Silver Spring Downtown Design Advisory Panel (DAP)

Project Name	8676 Georgia Avenue
File Number(s)	Sketch Plan No. 320230060; Preliminary Plan No. 120230150; Site Plan No. 82024XXXX
Project Address	8676 Georgia Avenue and 8601 Cameron Street

Re: 8676 Georgia Avenue
BHA Project # 2018-01

The following letter is a response to your SSDAP Comments on January 30, 2025.

PARTIAL ELEVATION AT CAMERON STREET

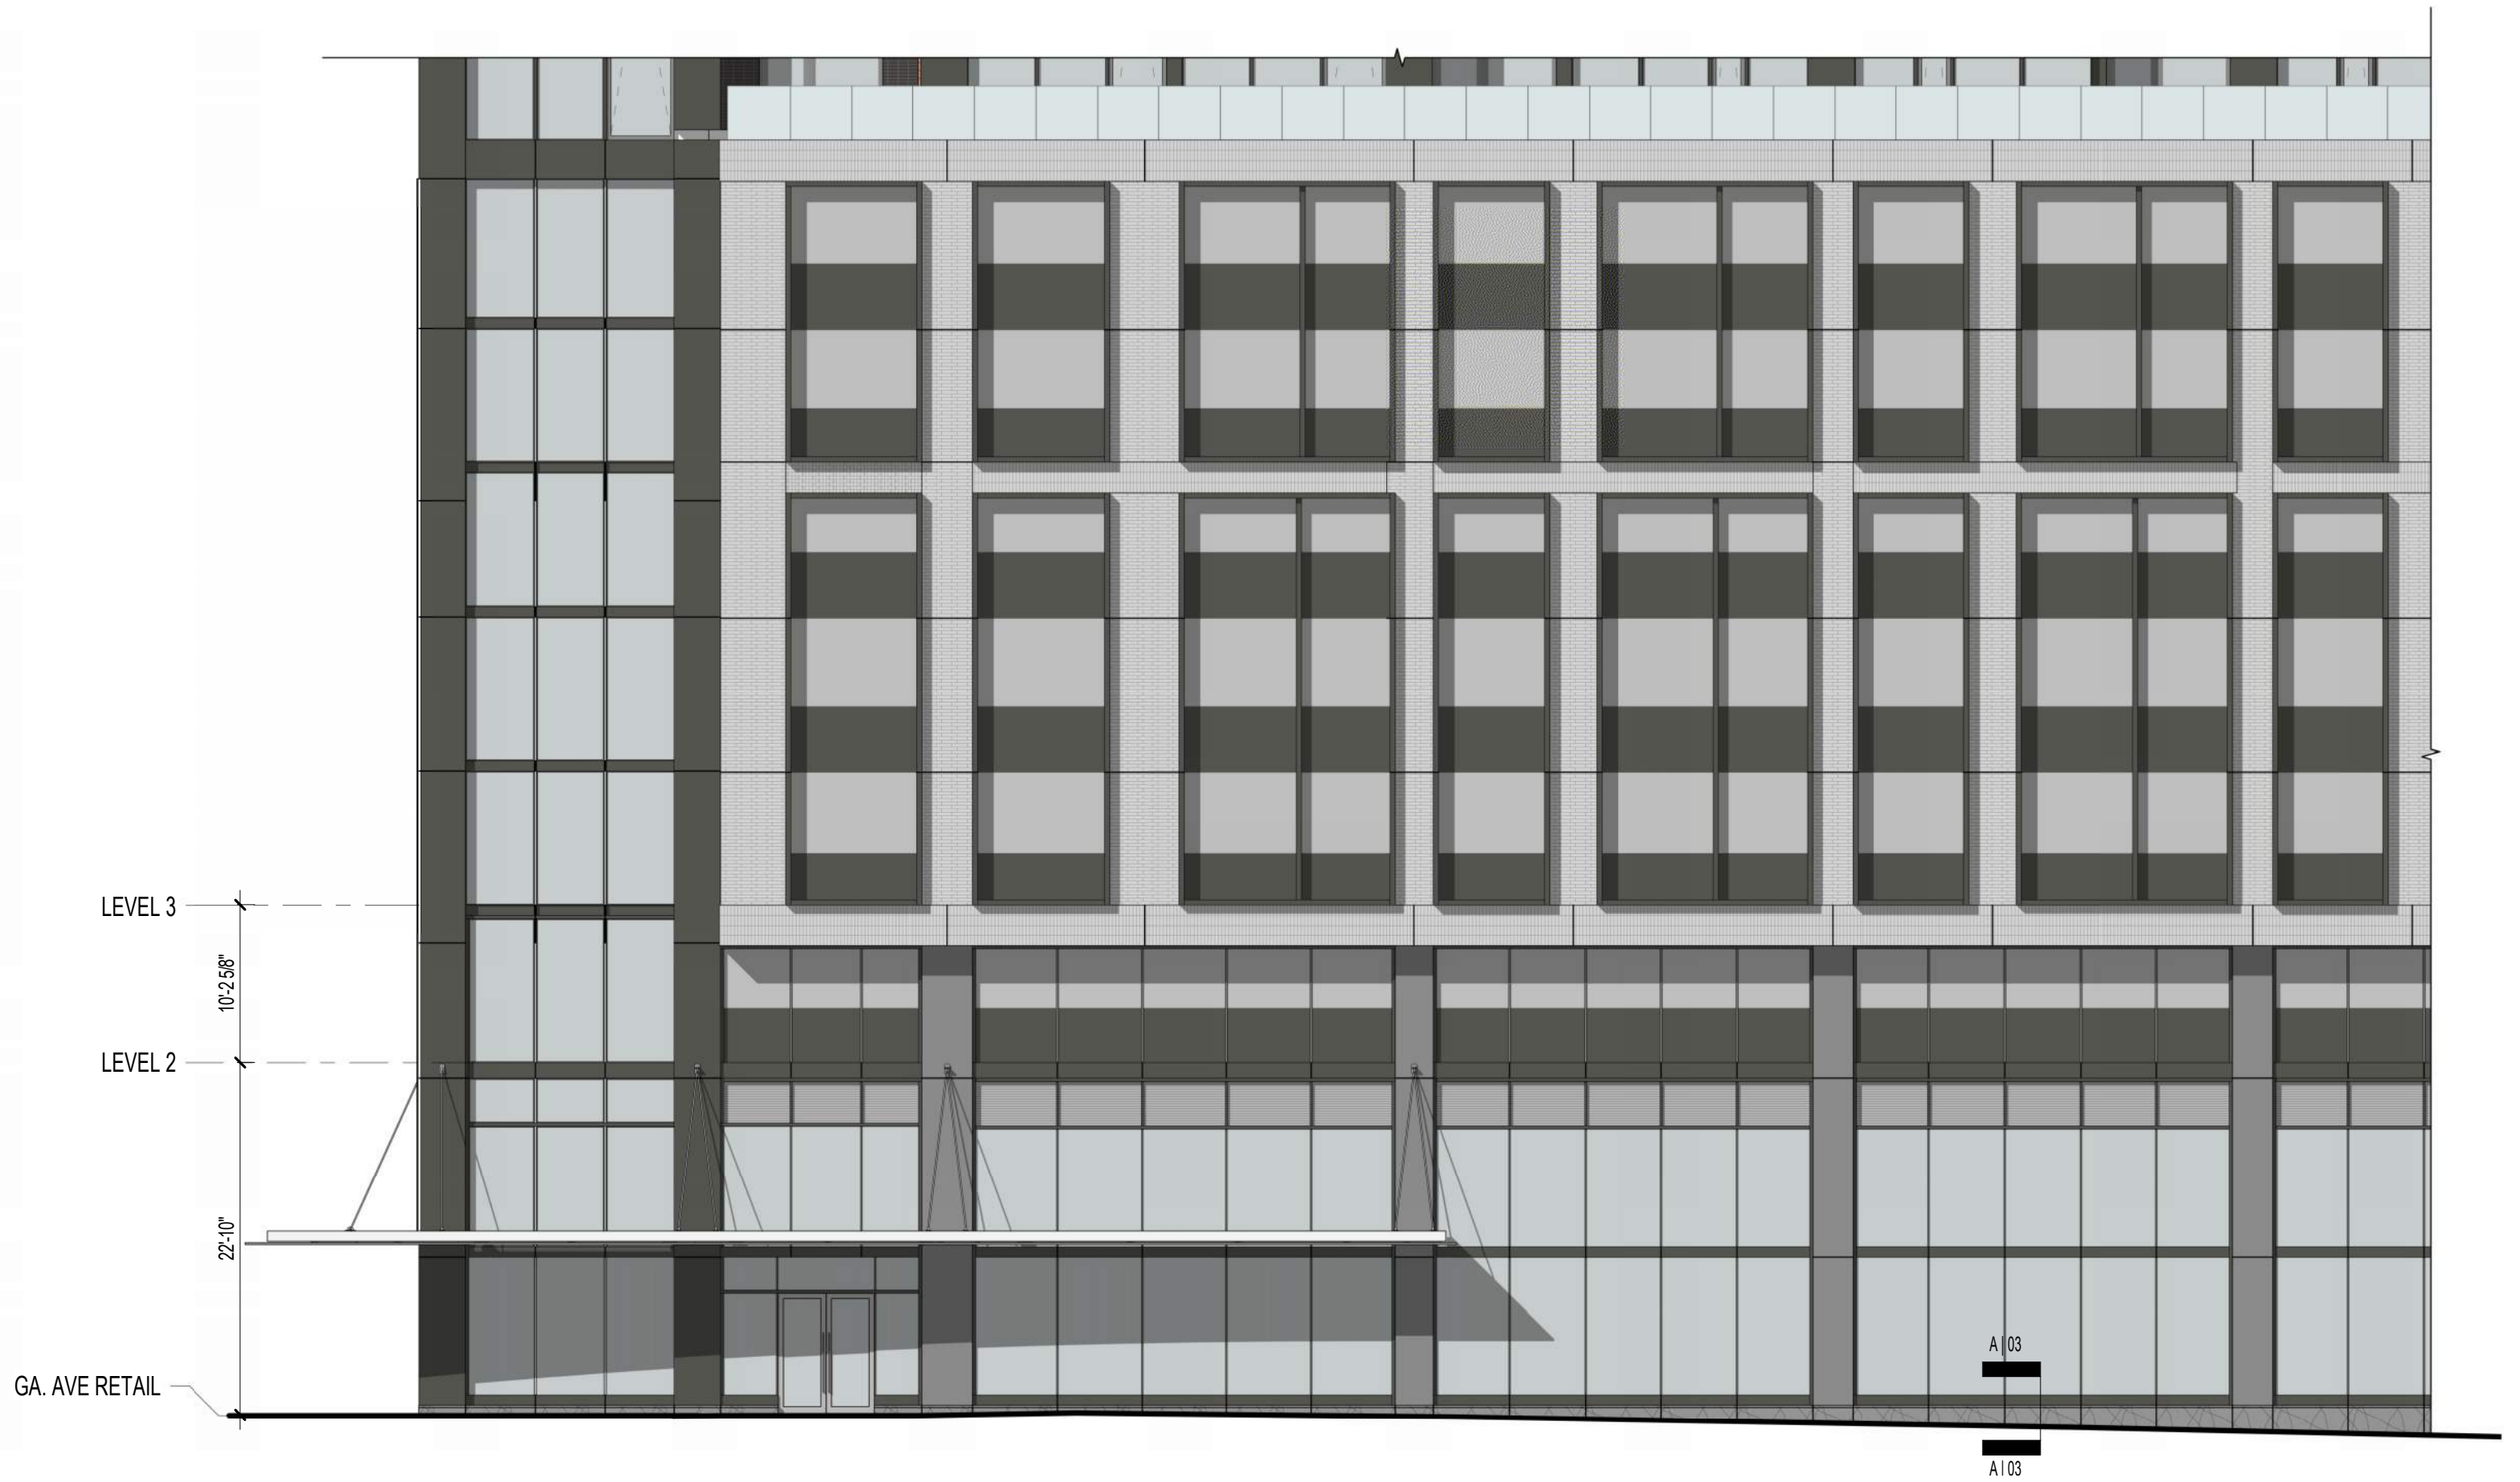
1. Incorporate the brick material from the base along Cameron Street on the base of the Georgia Avenue façade so that it reads as one building base that is broken by the transparent glass treatment at the Georgia/Cameron corner. Bring the vertical bay expression from Cameron Street onto the Georgia Avenue façade as much as feasible.

Scheme B on Georgia Avenue introduces brick along the parking garage façade that has the same articulation as along Cameron Street. The corner bay of the building breaks the floating brick base and comes to the ground. By wrapping the brick on Georgia Avenue facade, the same base, middle, top relationship holds on all sides of the building.
